CITY OF STAR

LAND USE STAFF REPORT

FILE(S) #: FP-25-05 Final Plat, Stardale Place Subdivision

The Applicant is seeking approval of a Final Plat for Stardale Place Subdivision consisting of 22 residential lots and 4 common lots on 3.39 acres. The property is located at 331, 343 and 385 N. Center Street in Star, Idaho, and is generally located on the southwest corner of N. Center Street and W. 3rd Street. Ada County Parcel No's. R8108001065, R8108001125, R8108001183, R8108001185, and R8108001240.

PRELIMINARY LANDSCAPE PLAN

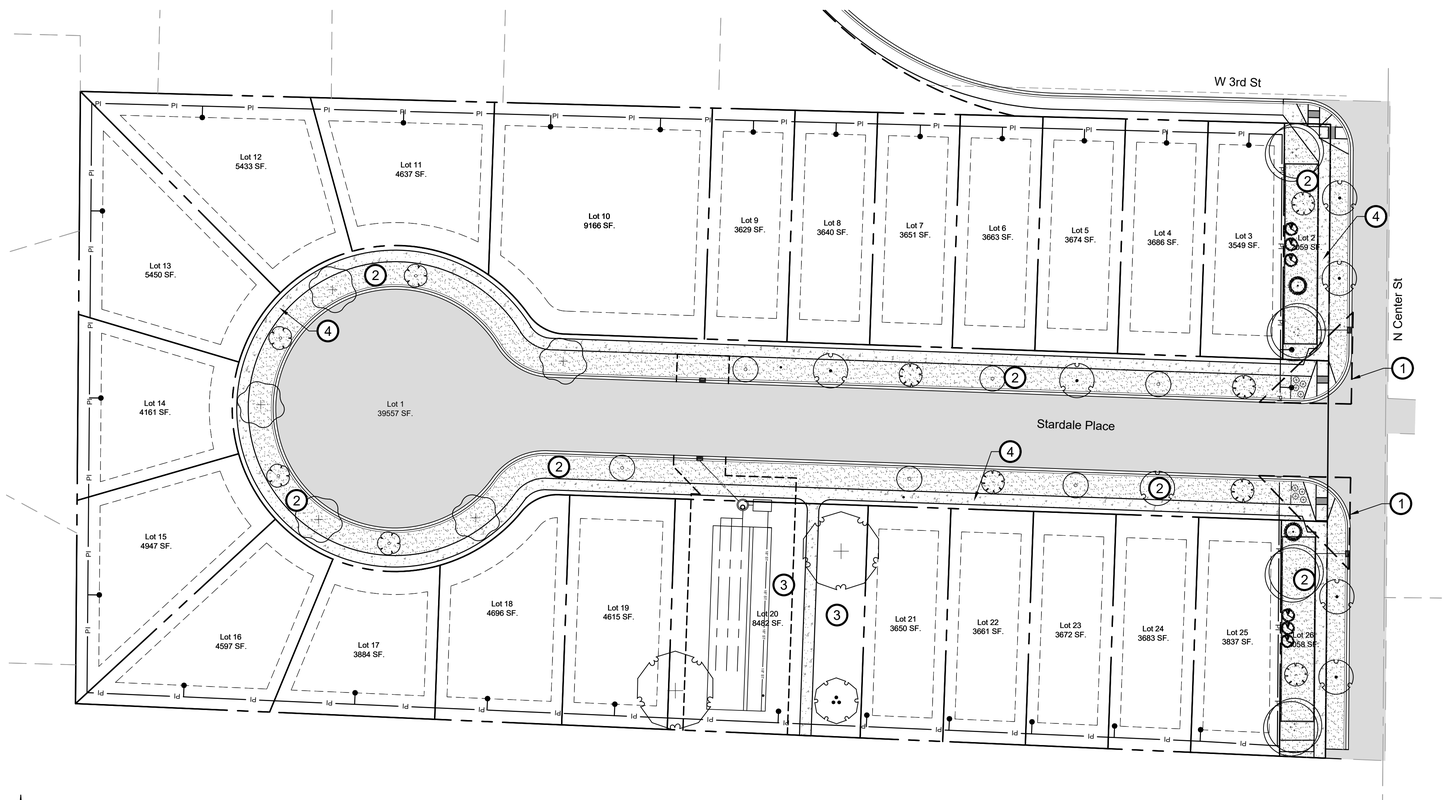
Landscaping - As required by the Unified Development Code, Chapter 4, Section B-7-C-3 Street Trees; the minimum density of one (1) tree per thirty-five (35) linear feet is required. The landscaping plan as submitted appears to satisfy this requirement. The applicant shall use "Tree Selection Guide for Streets and Landscapes throughout Idaho", as adopted by the Unified Development Code. **The included landscape plan appears to satisfy the tree requirements. The plan indicates native seeding in the park/open space. The applicant shall update the landscape plan and include grass within the open space area. The updated plan shall also detail the site amenities, including a gazebo and park benches.**

9. **Prior to signature of final plat, the applicant shall submit a revised landscape plan removing the native seeding and showing grass within the park/common area lot. The plan shall also detail the 2 site amenities (gazebo & benches).**
